Nasa Hitech Style Limited

22 May 2022

Observations

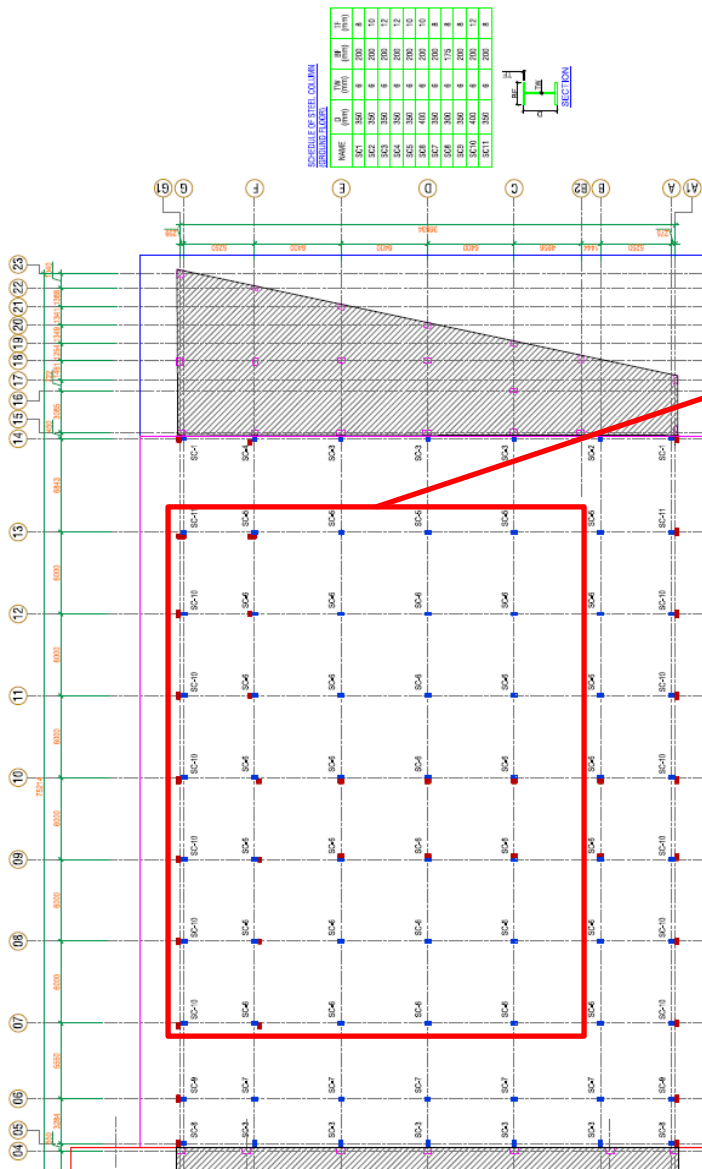
Factory engineer considered the rebar strength as 72.5 ksi (500 MPa) and MS plate strength 50 ksi (348 Mpa) in the design report. But material test reports of rebar & MS plate were not available on-site.

The factory is required to verify in-situ material strength for rebar and MS plate to confirm the design strength. Otherwise, revise the design report considering minimum material strength for rebar and MS plate.
